**5R110W
Remanufactured
Valve Body**

F05R110

5R110W Pressure Switches Notice

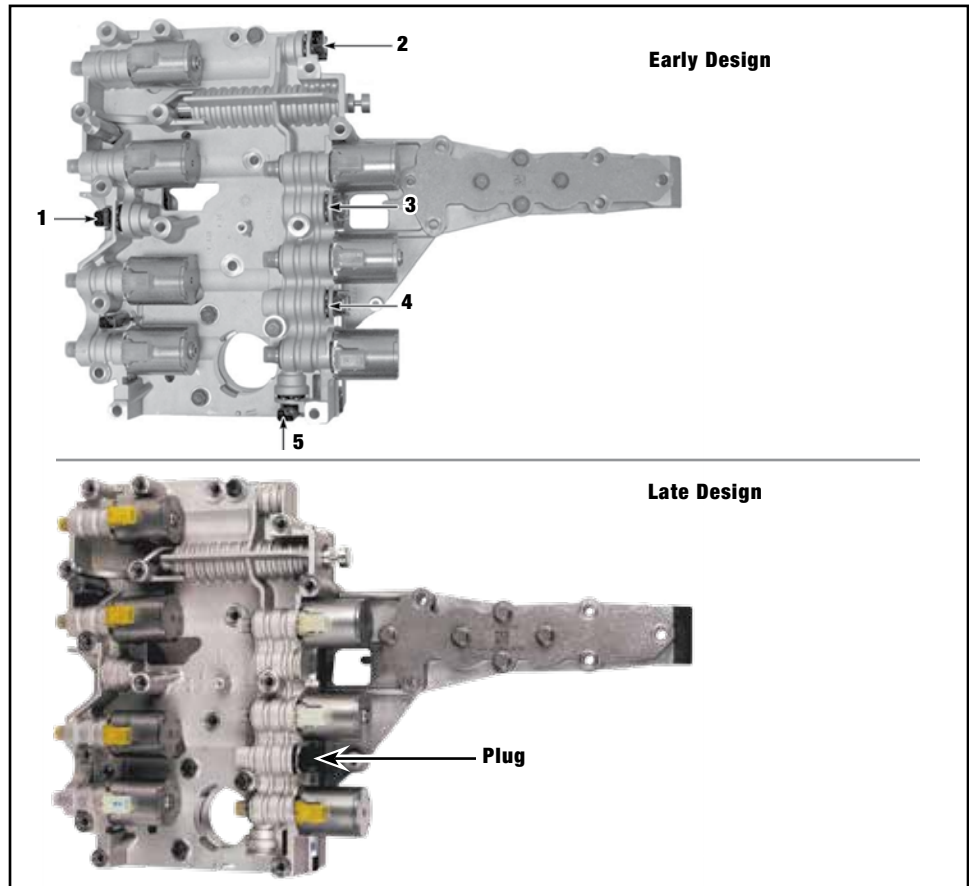
5R110W solenoid body **F05R110** is serviced without any pressure switches. Your original solenoid body may have one or five pressure switches depending on model year. The computer on these vehicles was never programmed to monitor the pressure switches and Ford removed them in late 2004. The later solenoid body may have one pressure switch with no wire going to it. In this application it is only used as a plug with the remaining four holes cast over.

Our remanufactured solenoid body is a late design with a plug installed instead of the one pressure switch. It will work perfectly fine in early one or five pressure switch applications. Simply leave the wiring for the pressure switches in position and not connected.

See Ford Special Service Message 17614 for more detailed information. See arrows above for locations of pressure switches on a five pressure switch version.

If you prefer to replace the harness both Ford and the aftermarket service the replacement harness without the wiring or connectors for the switches.
